Subject: **SBWR Test Program**

Reference: Purdue Testing Meeting, GIRAFFE Testing Program RAIs,
October 1, 1993

Requests for Information by Purdue University prior to
meeting on October 1, 1993.

GE ANSWERS TO PURDUE UNIVERSITY QUESTIONS ON SBWR SYSTEMS

Figure 6.2-1 SBWR Containment Boundary

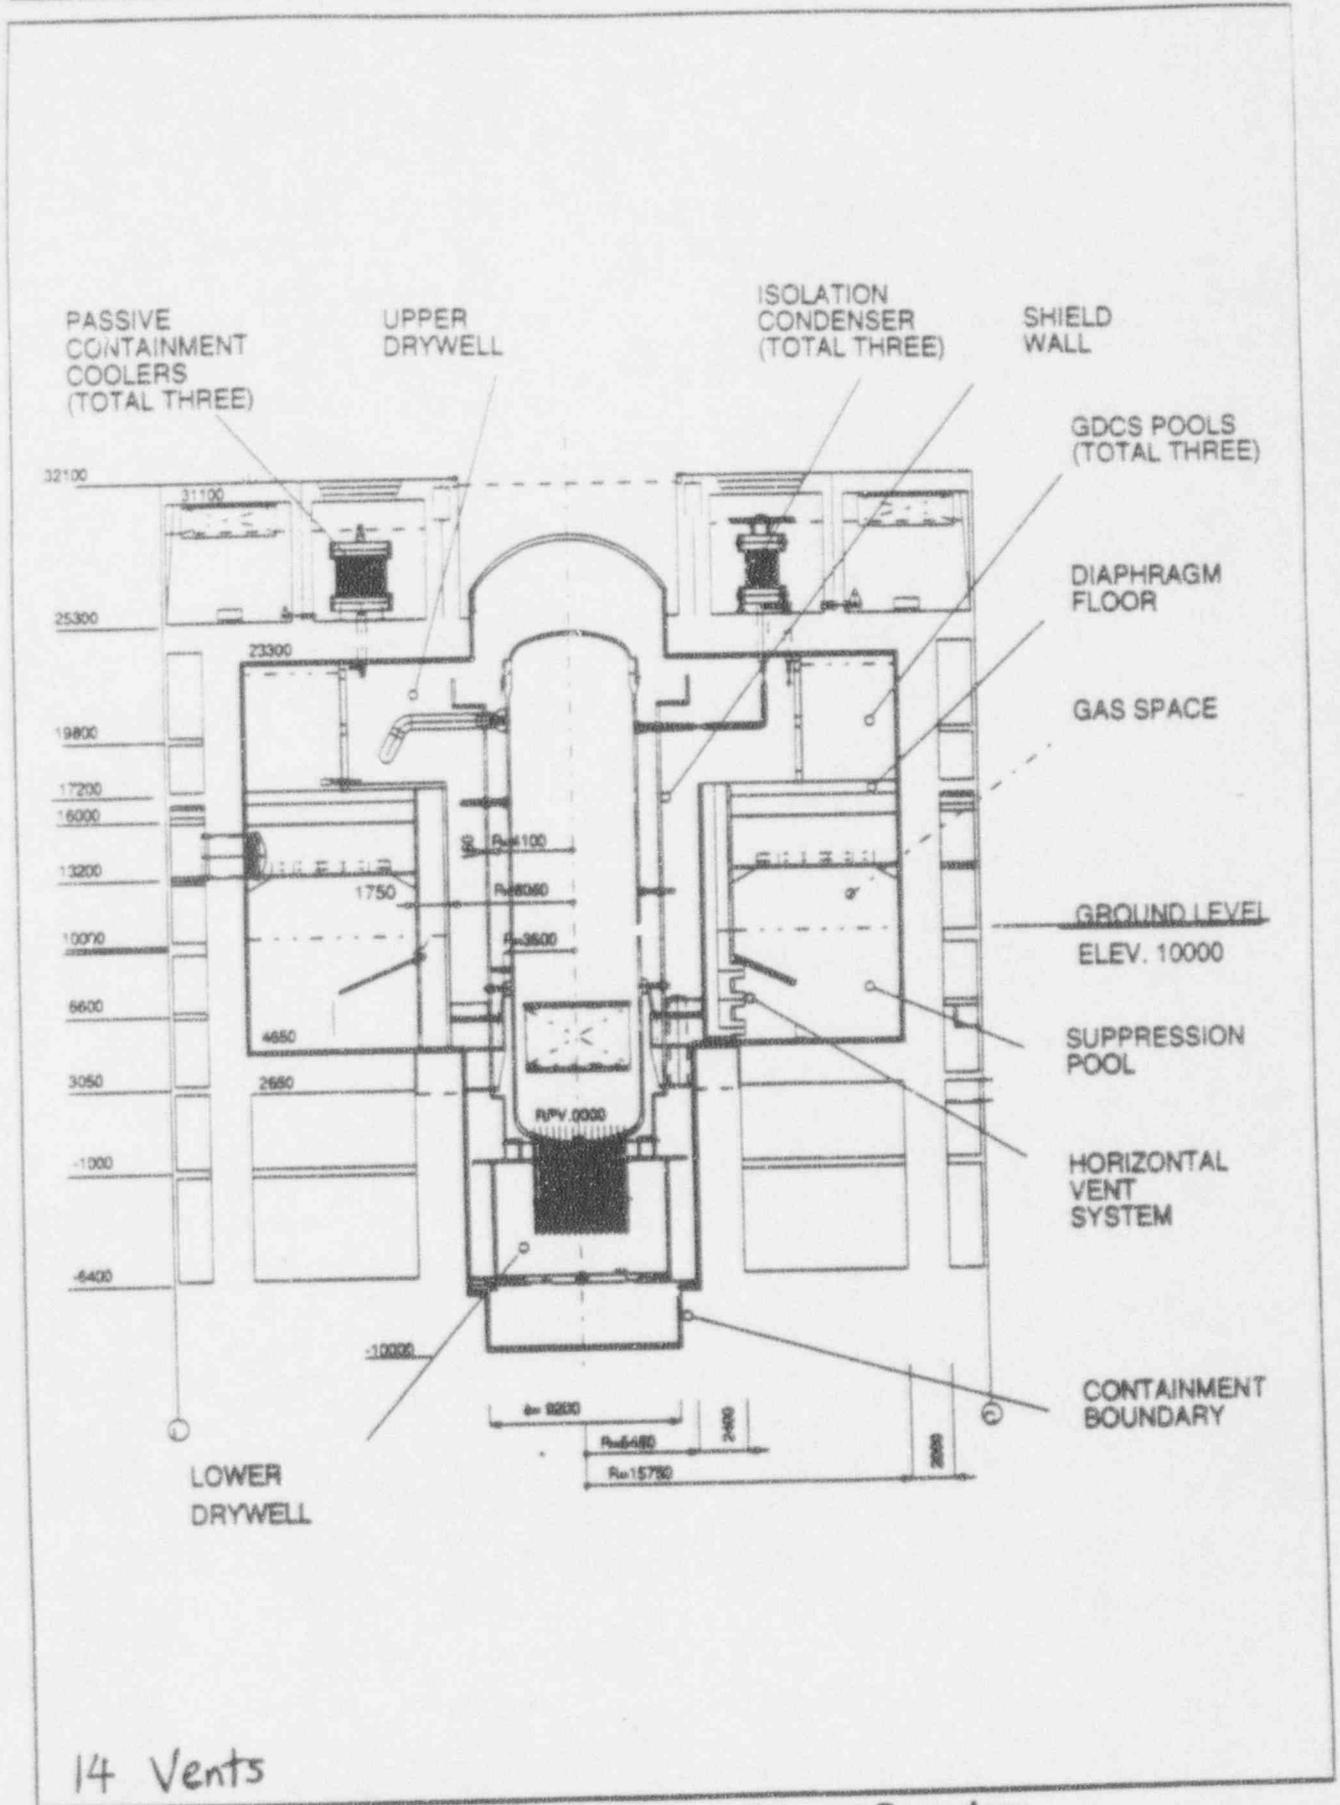
5. How are the upper drywell and the lower drywell connected? Detail of drywell design including neutron shield outside the vessel are needed. (drawings, flow area, loss coefficients).

5. UPPER AND LOWER DRYWELL CONNECTION DETAILS

- Detail drawing is attached.

- Flow Area: 14 vents, inside diameter = 0.82m

- Loss coefficients: assumed = 0 (Due to low flow rate through the vents)

Figure 6.3-18 Chimney Water Level, Inside Steam Line Break, 1 DPV Failure

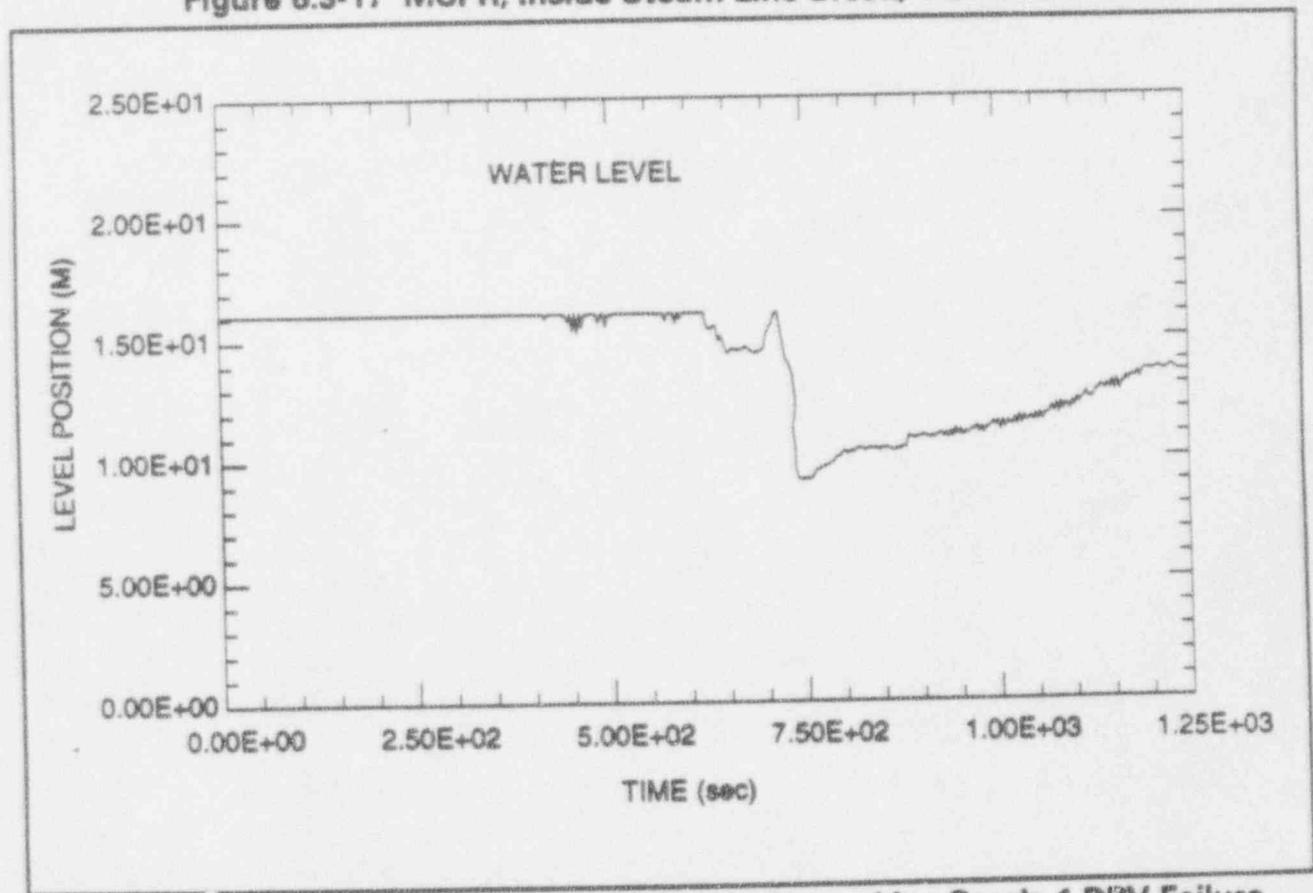
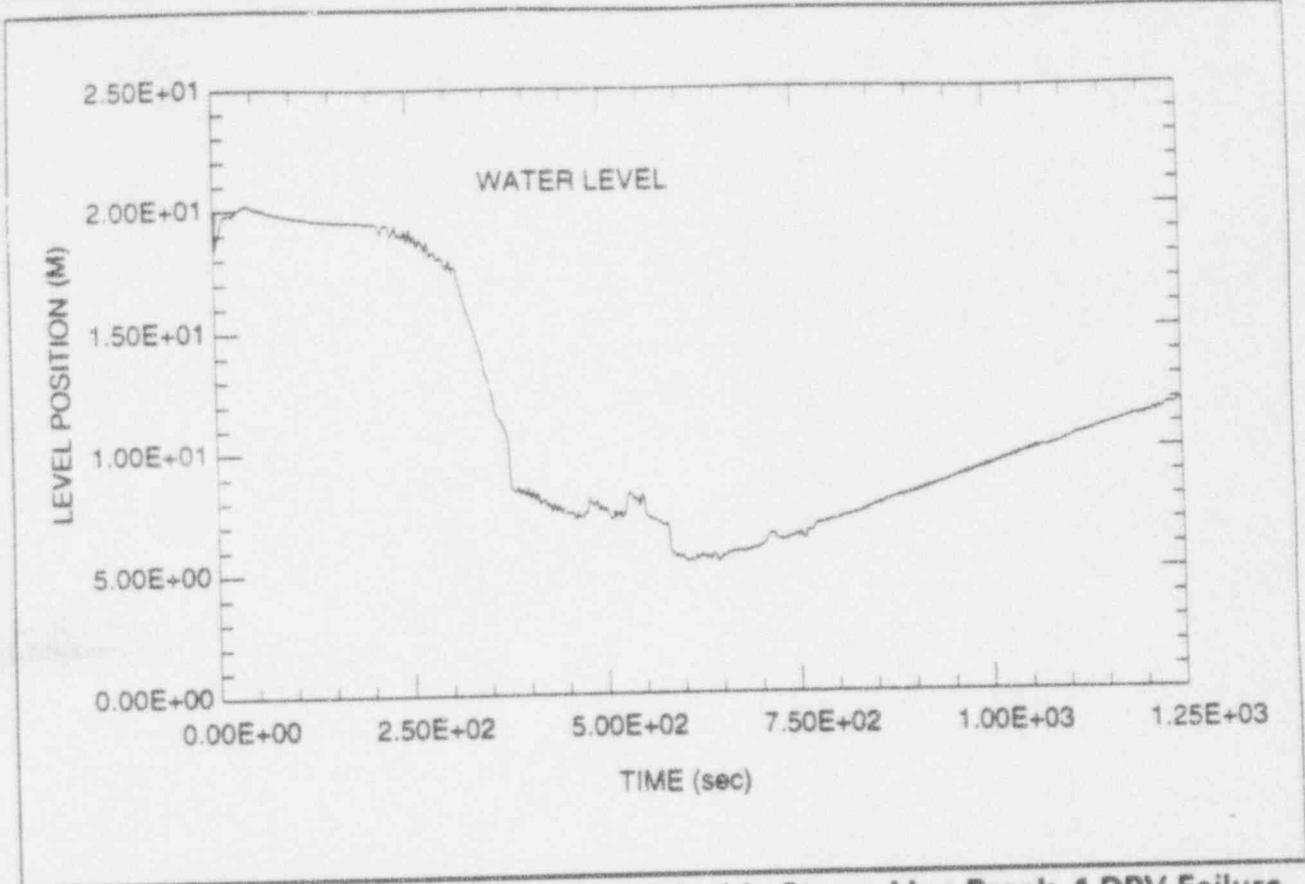
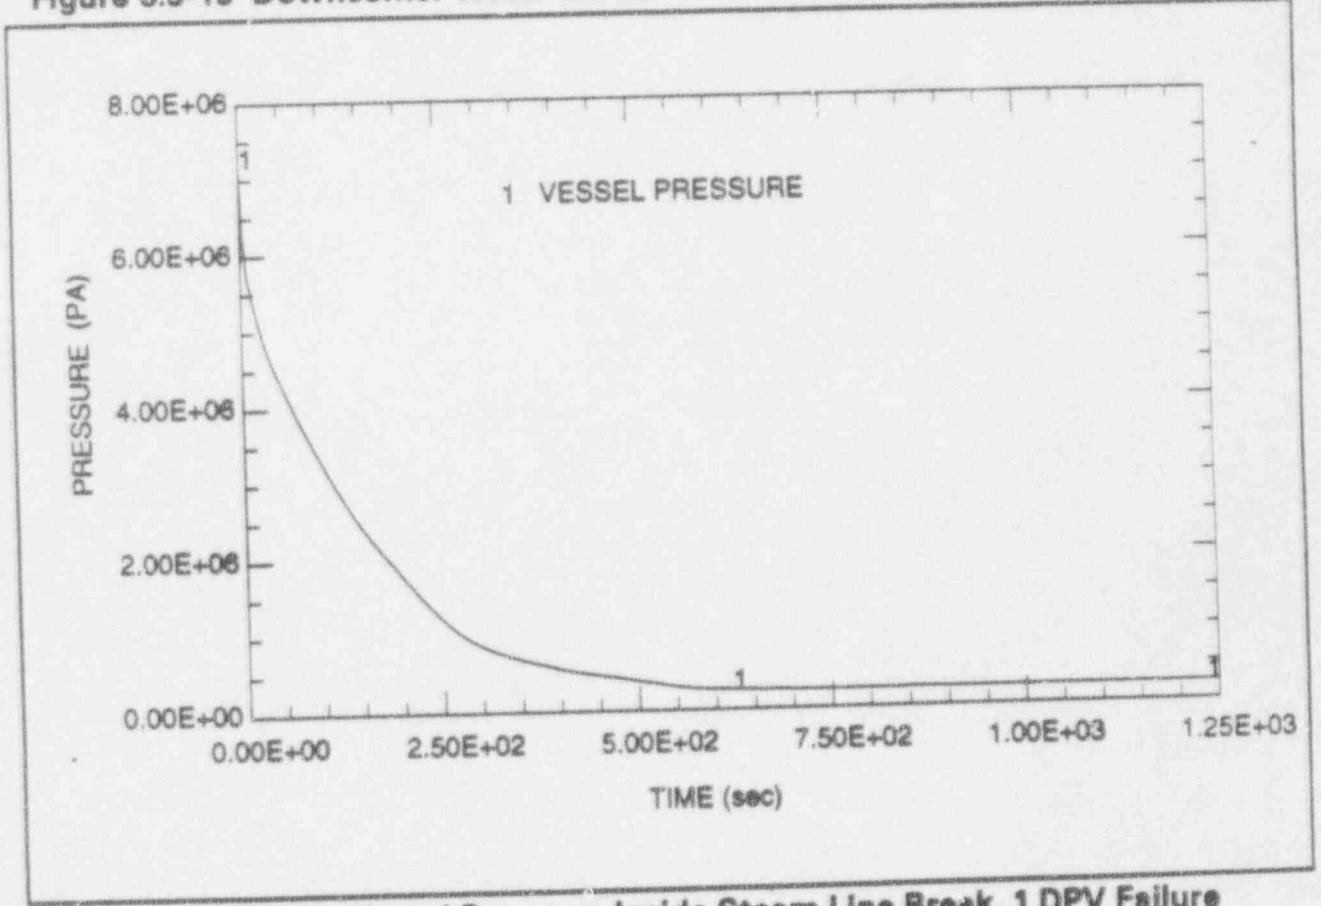
- c. Fuel and Auxiliary Pool Cooling Systems
 - d. Feed Water Lines
7. Can GE provide us with their code calculations of blowdown phase? We are interested in the thermal hydraulic parameters at about 150 sec. After MSL break, information on vessel liquid level (time dependent level due to swelling), quality, void fraction, and exact decay heat power levels will be useful.

Lower Plenum	0.24
Channel	0.63
Bypass	0.62
Chimney	0.66
Steam Dome	1.0
Downcomer	0.70
- Vessel Pressure @ Dome: 349.4 psia
- Quality @ Dome: 1.0
- Power @ 150 sec.: 5.78×10^7 watts

(Water level and pressure as a function of time is shown on attached figures.)
